FINAL TECHNICAL MEMORANDUM

TO: Dan Heilig, Wyoming Outdoor Council and
Jill Morrison, Powder River Basin Resource Council
FROM: Jean Marie Boyer, PhD, PE, Hydros Consulting Inc.
SUBJECT: Review of ERM Water-Quality Modeling Study of Boysen Reservoir
DATE: July 1, 2019

Figure 19. ERM Figure Showing Impact of the Project for Case 01

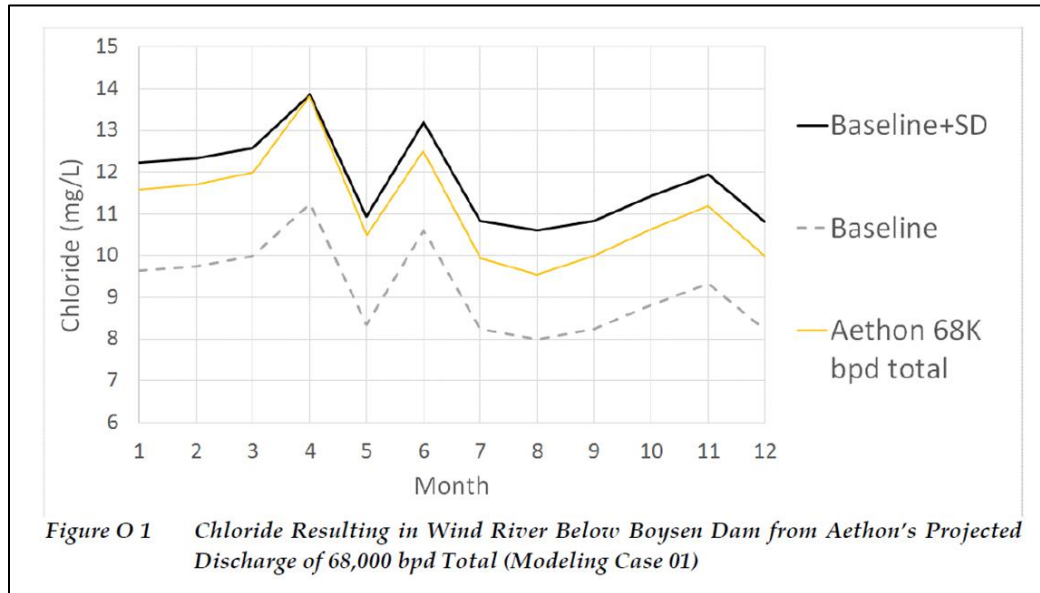
The analysis should be presented on a daily basis so that periods of larger impact are transparent. For example, from Figure O 1 (Figure 19), the reader could assume that April concentrations may only increase by up to 2.7 mg/L chloride, while the time-series data (Figure 17) show increases of up to 4.6 mg/L at times.

Figure 21. ERM Results for the Compliance Analysis for Dissolved Nickel (Red Line and Two Text Boxes Added)

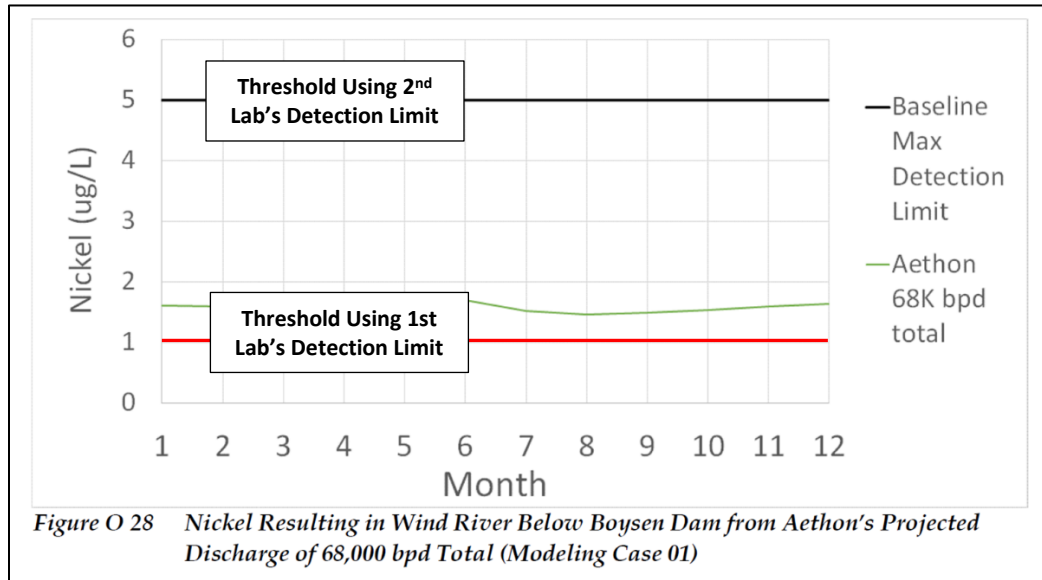
Using the approach developed by ERM, the results are displayed as Figure O 28 in Appendix O (see Figure 21). Using the threshold of 5 ug/L (based on the 2nd lab's detection limit), it appears that the project will not result in degradation in the Class I section. However, if the lab change had not occurred (or if the minimum DL was chosen), then the conclusion would be that degradation would occur.

Overall, this method and its implementation are flawed.

Figure 23. ERM Results for the Compliance Analysis for Dissolved Aluminum (Red Line and Two Text Boxes Added)

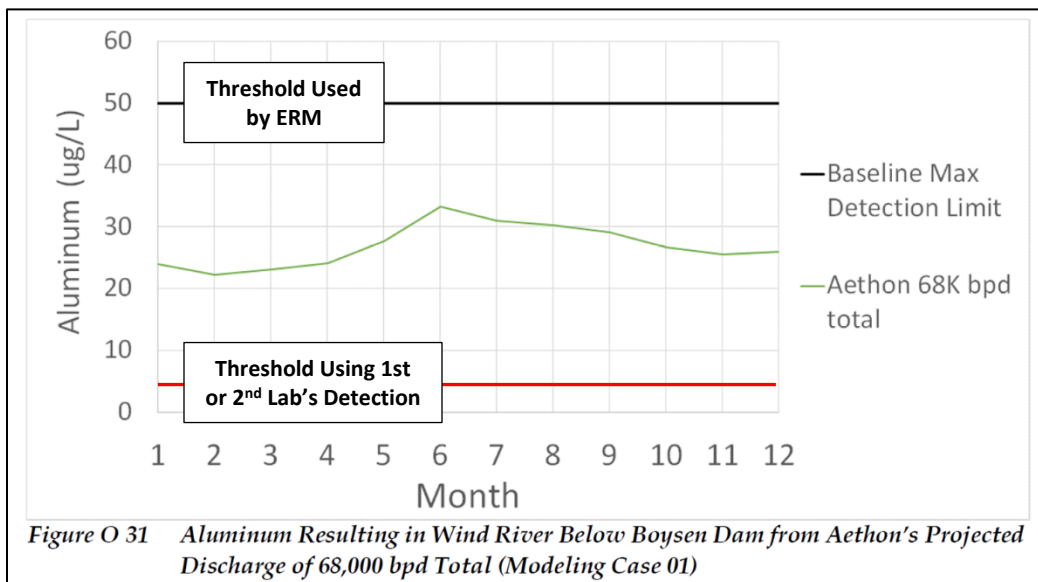
After lumping the model results and applying the adjustment factor (described above), the monthly model results are in the range of ~22-33 ug/L (Figure 23). This would show a problem if one compares these values to the 3-4 ug/L detection limits. ERM chose to set an alternative threshold of 50 ug/L and using that threshold, the project would not result in degradation.

The source of the 50 ug/L threshold appears to be the required detection limit for dissolved aluminum at the end of the pipe (WDEQ, 2019a). This 50 ug/L detection limit does not apply to the Class I segment of the Wind River (since it is not effluent) and use of this value by ERM for compliance is wrong.
